Enclosure 3  
Meeting Summary Handouts  
of the January 19, 2012  
ROP Public Meeting

# **NRC Staff White Paper on Performance Indicator Validity during Extended Shutdown and Start-Up Conditions**

**Tentative NRC Response to  
FAQ 11-12, FitzPatrick Downpowers**

Diagram 1: Low flow area with debris build-up behind Boot

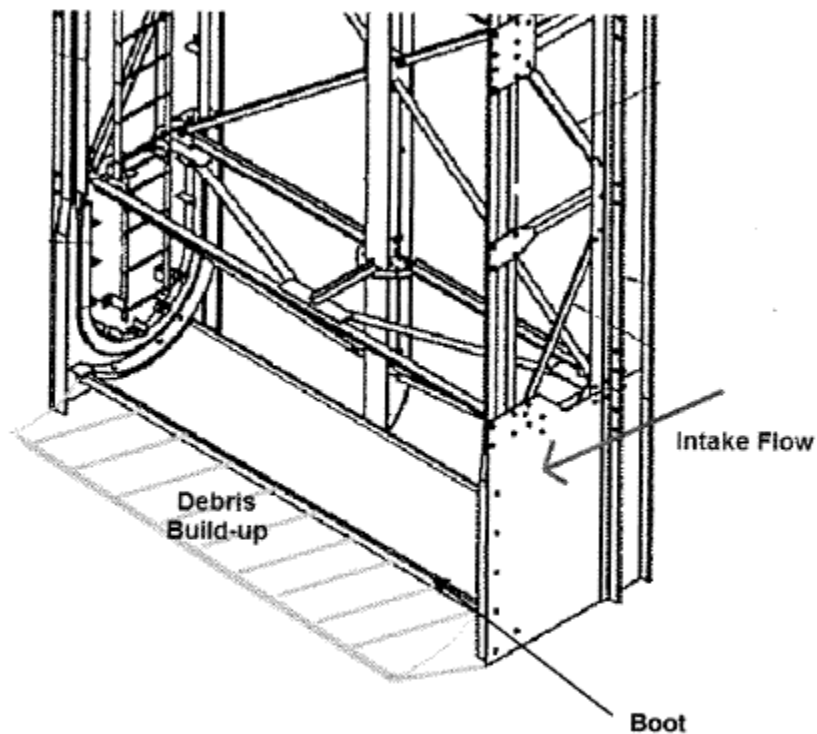
Based on the need to downpower the unit JAF performed an apparent cause evaluation and determined that the fouling observed was from a previously unidentified source. Based on the design of the boot and the cement, it appears that a low flow area may be forming just past the

boot. There is a possibility for small debris such as silt, sand, and broken zebra mussel shells to settle in this area south of the screens (pump suction side). In this area, the silt may settle out past the boots and build up to a level to meet up with the process flow. This condition would only take a short period of time to build-up and then would remain in the condition until cleaning could remove the debris.

During normal operation, this debris build-up is not a significant threat to fouling because the debris is settled. However, this area becomes vulnerable when the gates are installed because of the change in flow patterns and increased velocity.

During the maintenance activities beginning on 6/6/2011, the south gate was inserted to provide protection for the divers. The installation of the gate caused an increase in flow, which apparently caused the settled debris in the vicinity of the gate to be picked up by localized turbulence, resulting in fouling of the condenser. The apparent cause evaluation postulated

These downpower events should be excluded from the indicator. The licensee had experienced condenser fouling with the original traveling water screen design and although the travelling water screens had been replaced with a new design that previous operating experience was considered in planning the work on the new screens. The licensee took reasonable steps to prevent intrusion by cleaning the forebays and provided normal operating procedural guidance for monitoring condenser differential temperatures and backwashing the condenser water boxes. Since this was the first time the boot inspections had been performed, there was no way to reasonably anticipate that the debris south of the travelling water screens would have been sufficient to cause the observed condenser fouling. In addition, the on-line schedule for that week had a contingency action to perform a downpower in order to support backwashing activities. This was shown as a contingency because there is no way to accurately predict if the condenser will foul or the speed with which it will reach a point requiring a downpower.

Although the licensee may have been aware that condenser fouling during the maintenance or inspection activity could potentially cause a downpower, the licensee was not planning to downpower to conduct the maintenance/inspection. The licensee stated in the FAQ that it could not reasonably anticipate that the debris south of the travelling water screens would have been sufficient to cause the observed condenser fouling. This statement indicates that the licensee was not planning to downpower. Therefore, the staff considers the downpowers to be unplanned.

NEI 99-02 has guidance for allowing contingency downpowers under certain conditions (page 14, lines 6-8) and anticipatory downpowers in response to certain external events (page 14, lines 38-40) and environmental events (page 14, lines 42-47, and page 15, lines 1 – 29). The external and environmental event guidance reflects situations that are not caused by the licensee and for which the licensee cannot predict or control the timing. Although marine debris is environmental matter, the licensee's action of closing the gates created new flow patterns that transported the debris into the condenser, which has happened at this site in the past. NRC staff does not consider this situation to qualify for the contingency or external or environmental event exclusions in NEI 99-02.
